Re: Turkey Point Units 3 and 4
Docket Nos. 50-250 and 251
License Amendment Request No. 204
Spent Fuel Pool Criticality Analysis Taking Credit for Boraflex

Florida Power and Light Company
Turkey Point Units 3 and 4
Renewed Facility Operating License Nos. DPR-31 and DPR-41
Docket Nos. 50-250 and 50-251
License Amendment Request Regarding a Spent Fuel Pool Criticality Analysis for
Unit 3 Taking Credit for Boraflex

Evaluation of Proposed Changes

**Figure 5.5-5
Boraflex Cell Arrays (Unit 3 only)**

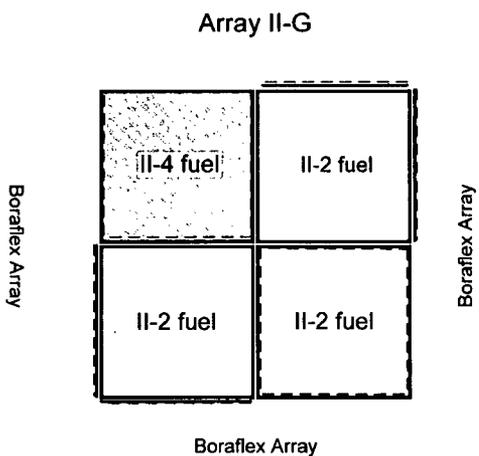
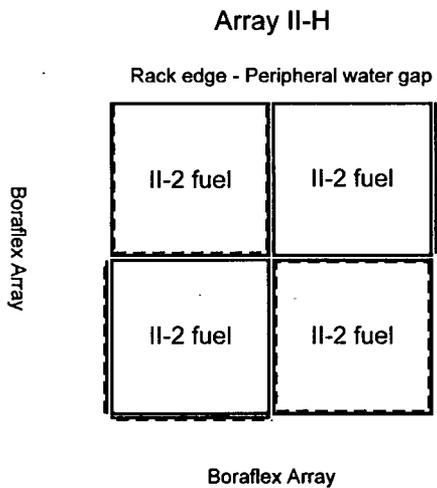
- e. Any 2x2 array of Region II that credits Boraflex and containing fuel shall comply with the allowable storage patterns defined in Figure 5.5-5.

This is the only new change provided by this LAR, which has not been previously approved by the NRC. The figure shows the arrays II-G and II-H crediting Boraflex material in the SFP. The acceptability of this change is discussed in Section 5.2 and Attachment 2 of this LAR. This addition to the TS will be in effect no later than 2400 hrs on September 30th, 2012. The added figure applies to Unit 3 only.

<u>Array II-G Definition:</u>	A 2 x 2 array of fuel containing three Category II-2 assemblies and one Category II-4 assembly.
-------------------------------	---

<u>Array II-G Definition:</u>	A 2 x 2 array of fuel containing four Category II-2 assemblies, facing the fuel pool wall, on the periphery of the racks.
-------------------------------	---

Note: These arrangements will be available until 2400 hrs September 30th, 2012.
